PINE BRANCH SUBDIVISION, RESUBDIVISION OF

LOT 1

APPLICATION NUMBER 21 DATE July 15, 2004

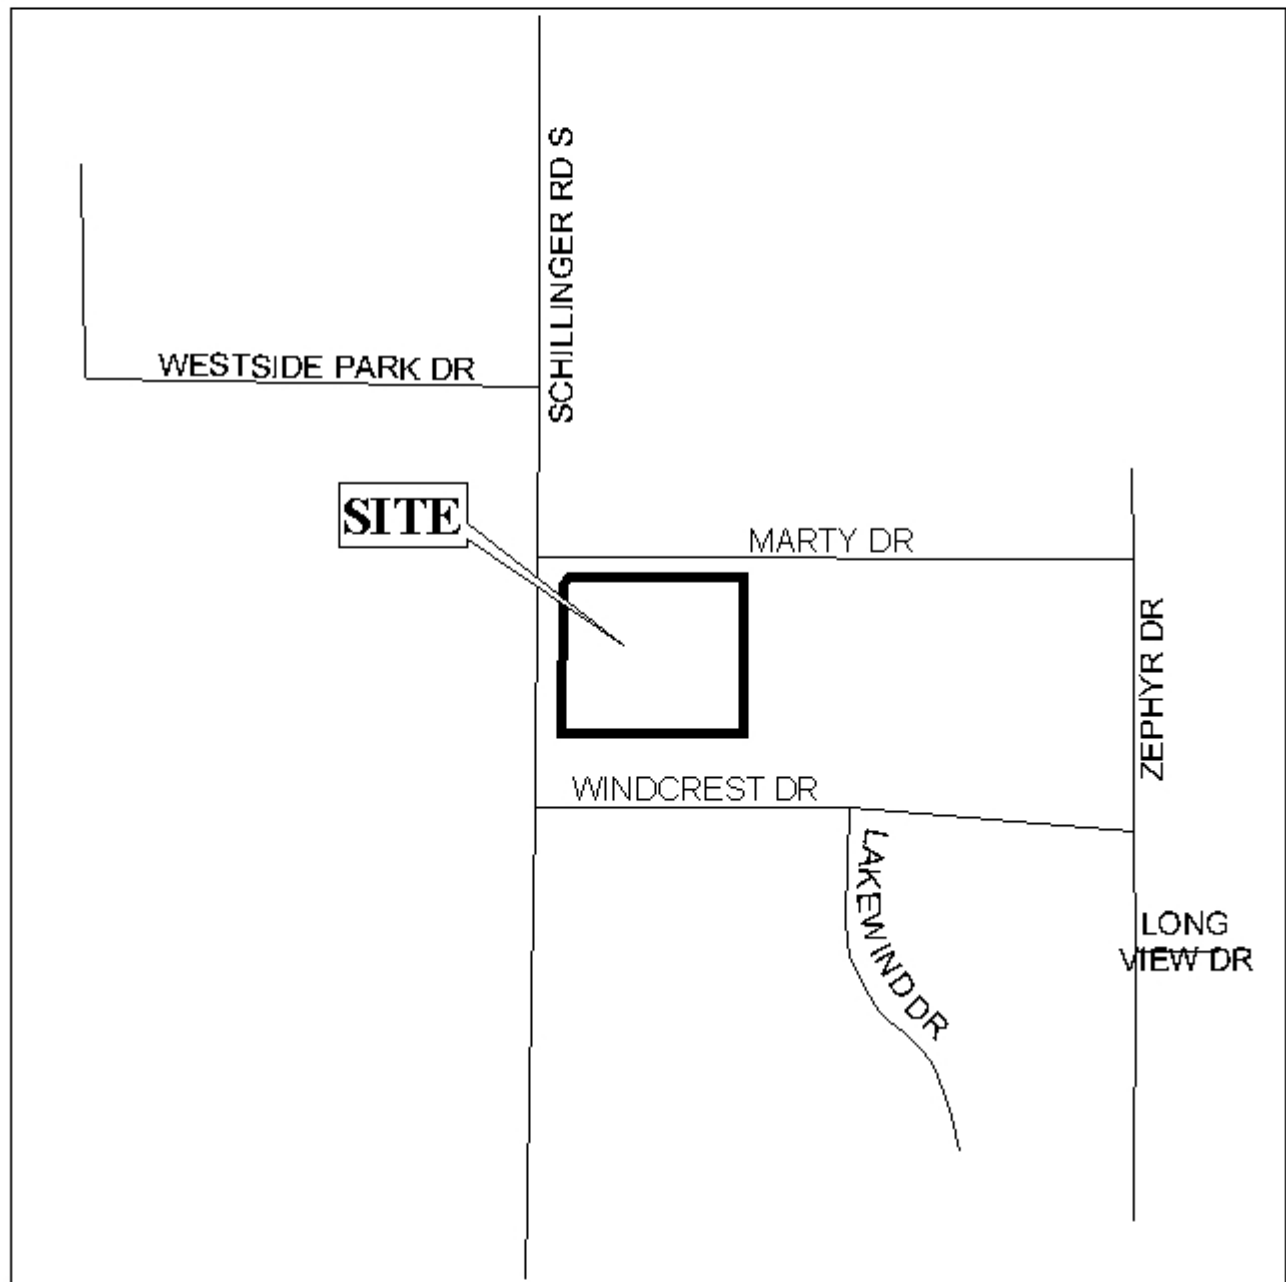
Engineering Comments: Must comply with the Mobile County Flood Damage Prevention Ordinance.

The plat illustrates the proposed 2 lot, 2.4 \pm acres subdivision which is located at the Southeast corner of Schillinger Road and Marty Drive. The subdivision is served by public water and individual septic systems.

The site fronts Schillinger Road, which has an existing right-of-way of 80 feet, is shown as a major street on the Major Street Plan, and as such require a 100-foot right-of-way. Therefore, the dedication of adequate right-of-way to provide 50-feet from the centerline should be required. Additionally, as a means of access management, a note should be placed on the final plat stating that both lots are limited to one curb cut each to Schillinger Road, with the size, location and design to be approved by County Engineering, should be required. Furthermore, if Lot 1 is developed commercially it should be denied direct access to Marty Drive.

This site is located in the County, thus a note should be placed on the final plat stating that any lots which are developed commercially and adjoin residentially developed property must provide a buffer, in compliance with Section V.A.7. of the Subdivision Regulations.

The plat meets the minimum requirements of the Subdivision Regulations and is recommended for Tentative Approval subject to the following conditions: 1) the dedication of sufficient right-of-way to provide 50-feet from the centerline of Theodore Dawes Road; 2) the placement of a note on the final plat stating that both lots are limited to one curb cut each, with the size, location and design to be approved by County Engineering; 3) the placement of a note on the final plat stating that if Lot 1 is developed commercially, it is denied direct access to Marty Drive; and 4) the placement of a note on the final plat stating that any lots which are developed commercially and adjoin residentially developed property must provide a buffer, in compliance with Section V.A.7. of the Subdivision Regulations.
